Subject: RE: Revised Legacy LF Cell 5 CQA Report

Per our conversation on Friday, January 23, 2025, the Legacy Landfill Cell 5 CQA report has been updated per your comments. In addition, attached is list of the questions you asked for clarification along with the associated response.

Answers to DEQ Questions:

FIGURE 3 - CONSTRUCTION PLAN
DRAINAGE LAYER / PROTECTIVE COVER PLAN

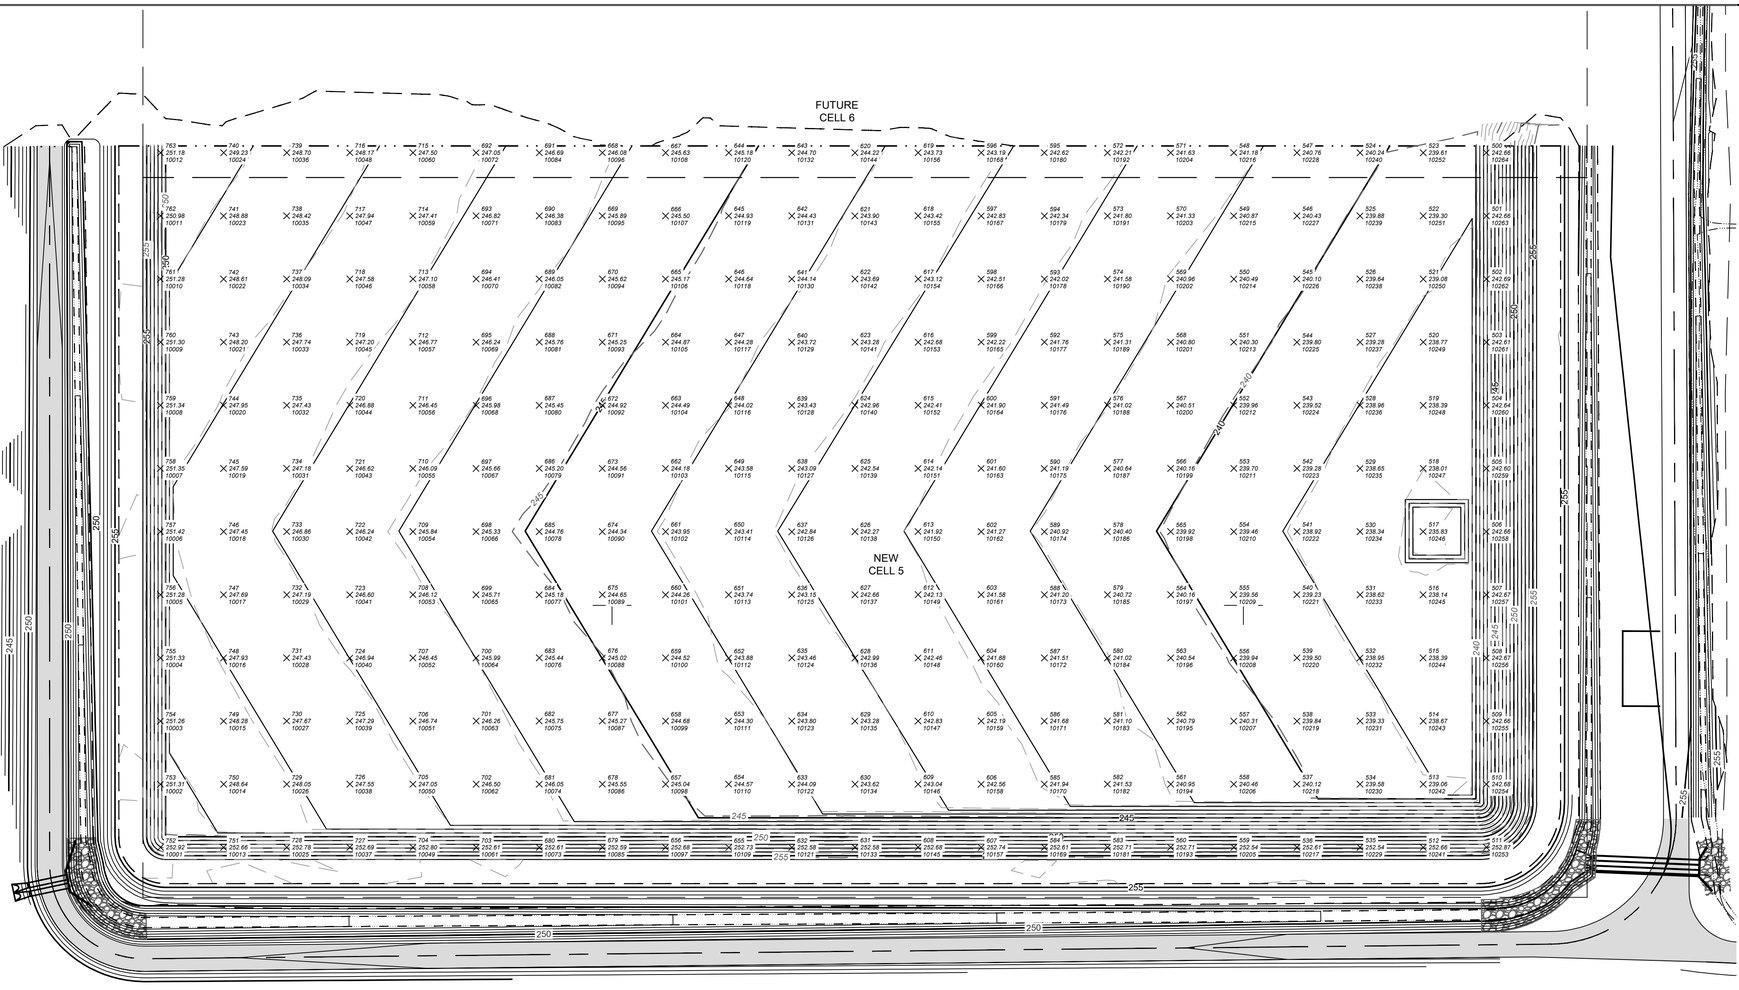
1. **Comment:** Why was the layout of the cell not the same as the permitted design?

Response: The construction plans were modified before construction began. The eastern boundary of Cell 5 was moved approximately 40 ft to the west to accommodate the concrete storage structure just east of the cell. The southern boundary of the cell was moved approximately 30 ft north to accommodate a wider stormwater ditch on the southern side of the cell. The adjustment reduced the area of the cell from 15 acres to approximately 14.7 acres.
